May 29, 2020

Don Julian Builders

Re: 2924 NW Audubon Ln  
Lot 1450 Winterset Valley  
Lee's Summit, MO

Apex Engineers Inc. observed the house under construction at the above referenced address. For the purposes of this report the house will be referred to as facing south. Our firm has been retained to address the following items from the rough-in framing inspection:

FIRST FLOOR PLAN

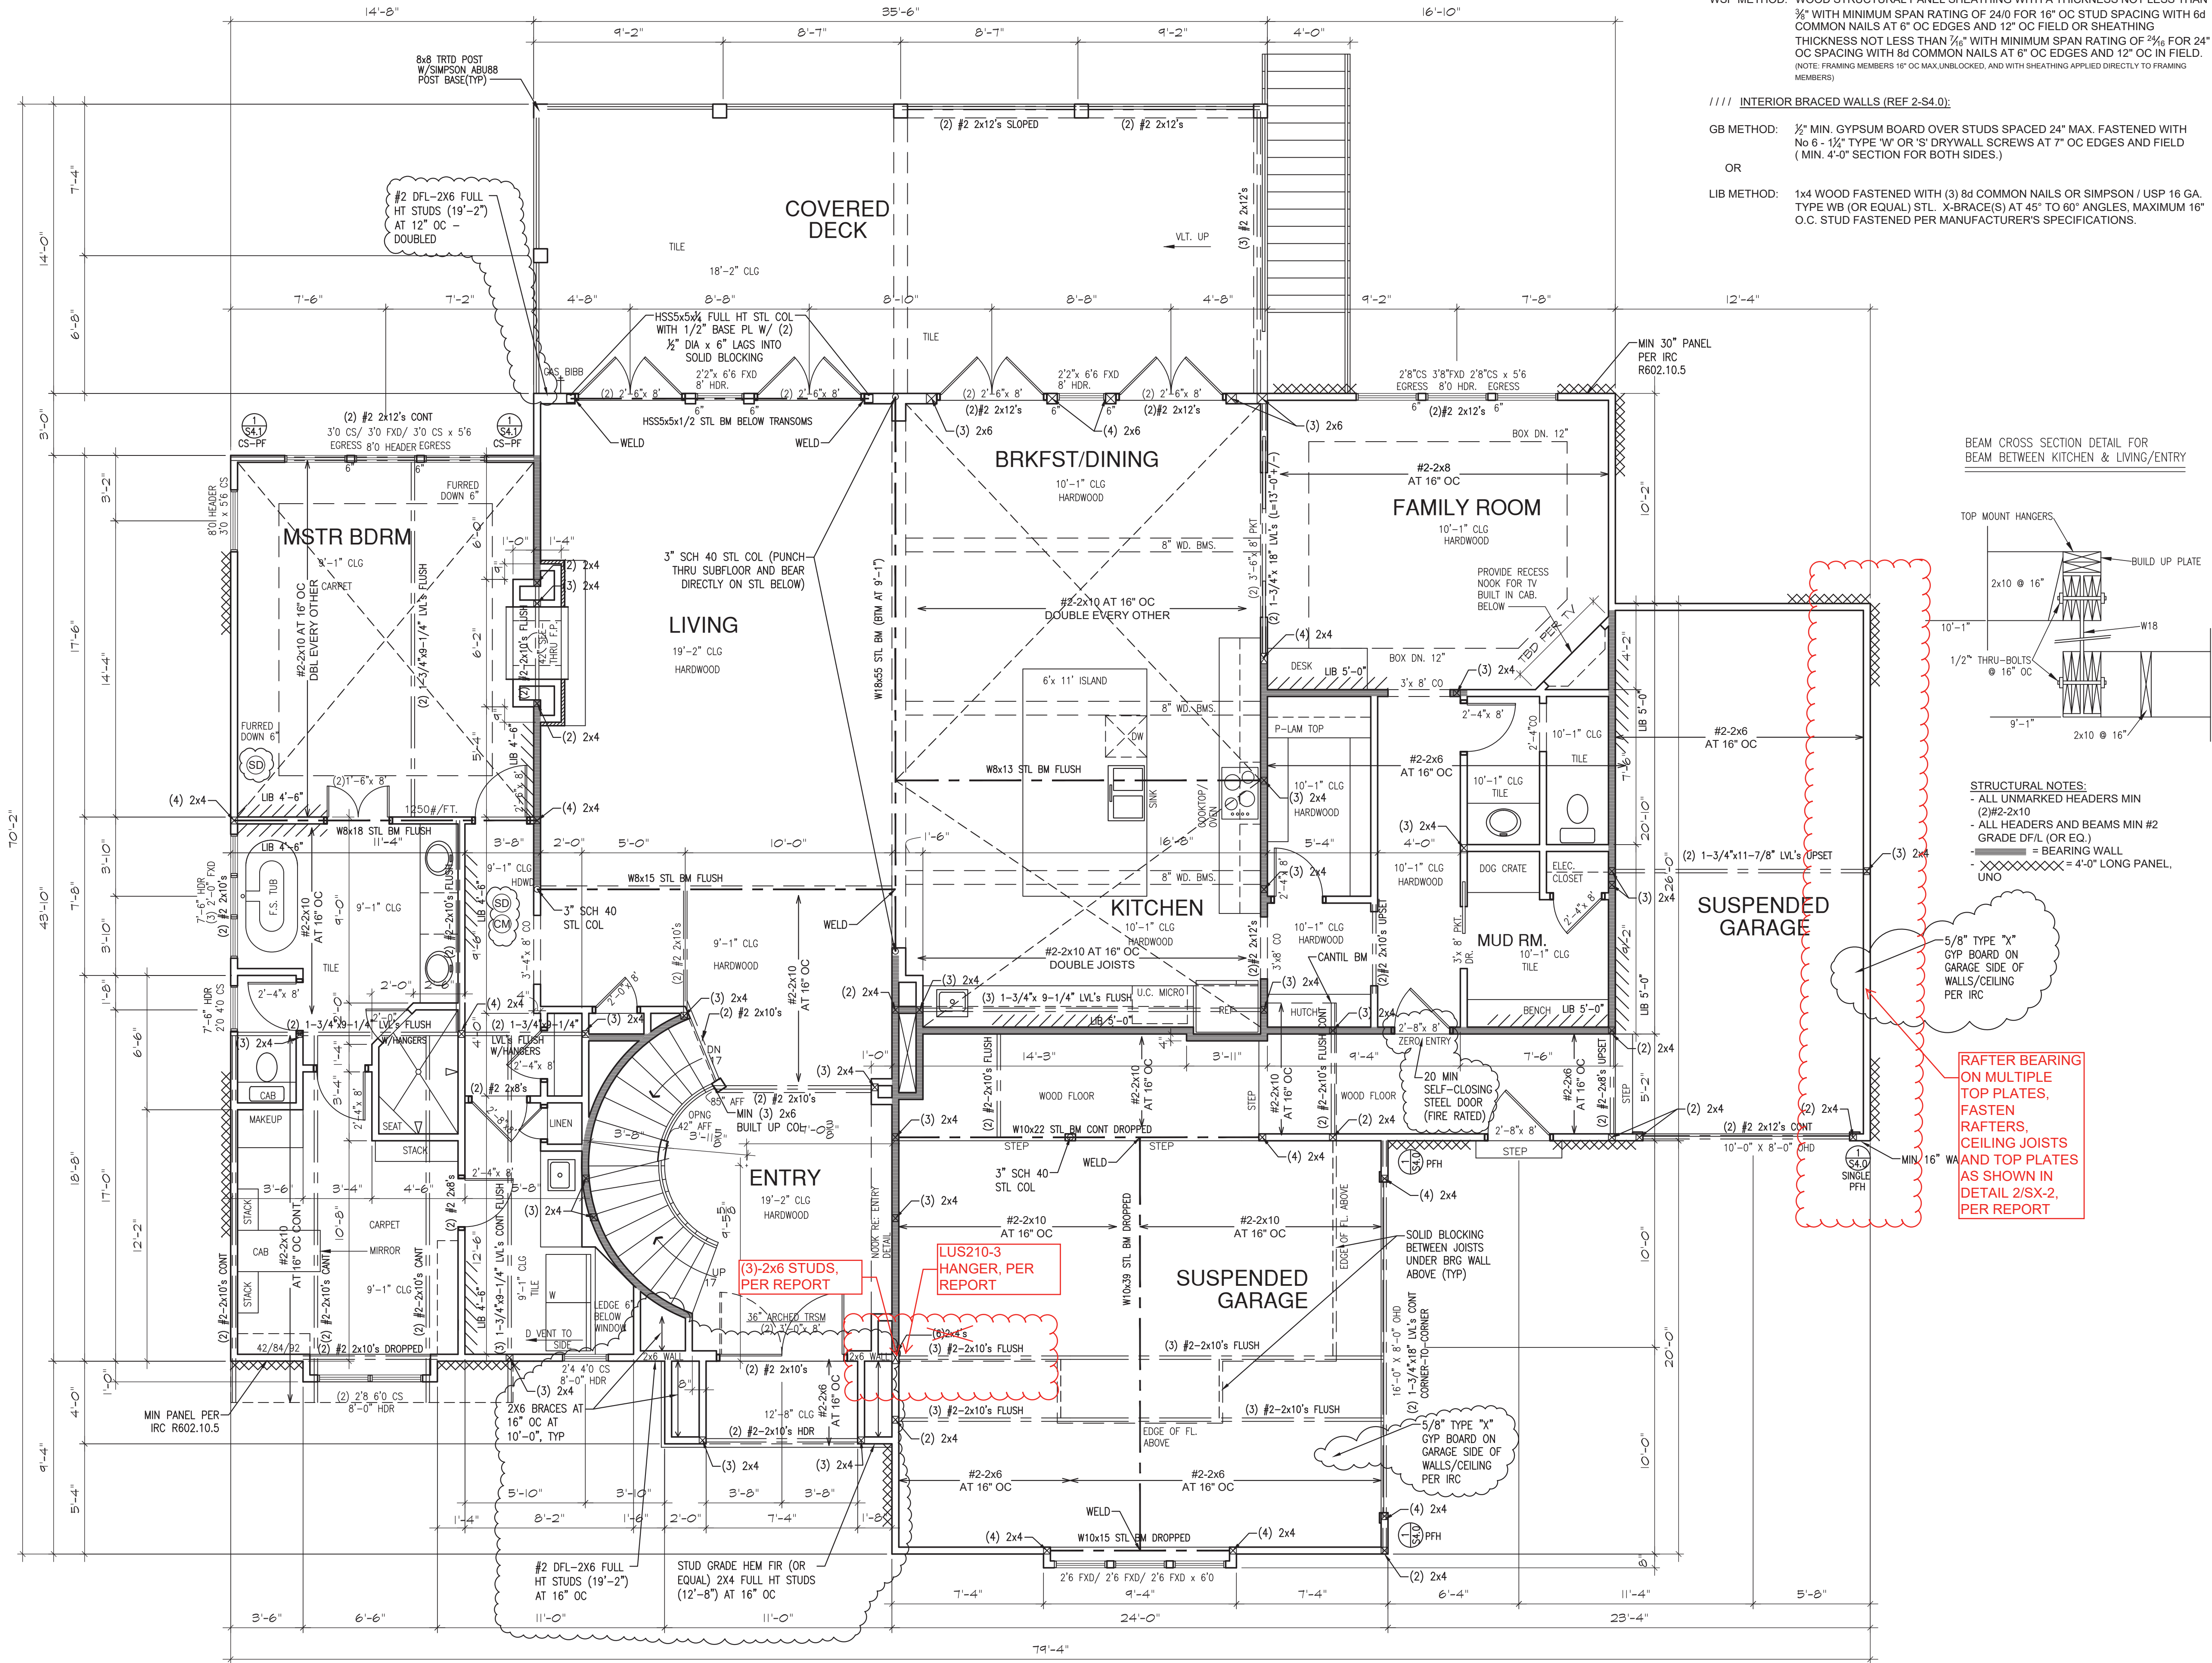
2. *Missing (6)-2x4 studs below (3)-2x10 in wall between entry and garage.*
  - Install a built-up wood column consisting of a minimum of (3)-2x6 studs, in lieu of the (6)-2x4 stud pack shown on the original plans.

## 2 | OPTIONAL RAFTER BEARING

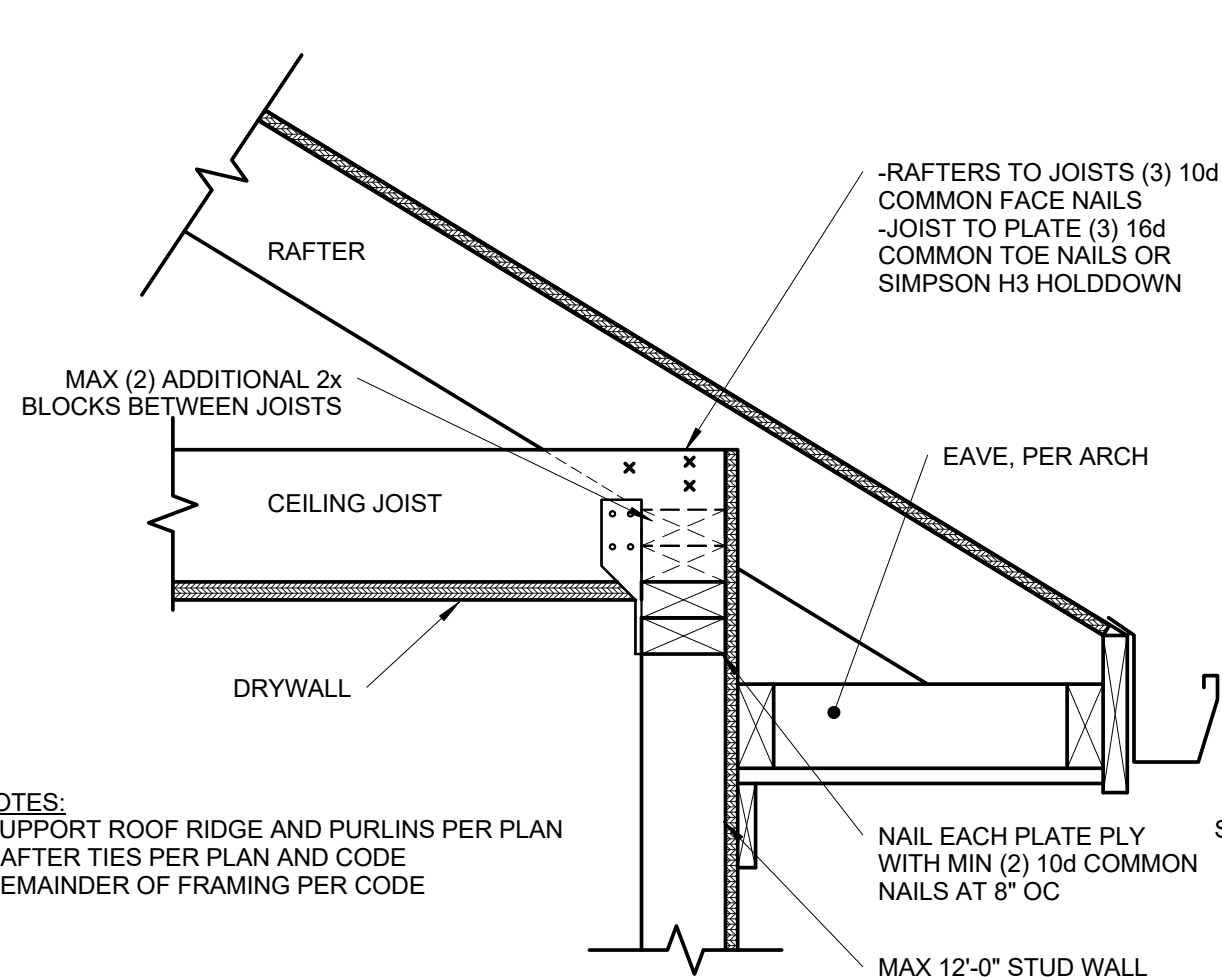
1. *Rafters bearing on multiple top plates on wall at east side of single car garage.*
  - The existing rafters, top plates and ceiling joists shall be fastened as shown in detail **2/SX-1**, attached to this report for reference. This detail is also shown on **11/S3.1** on the original plans.
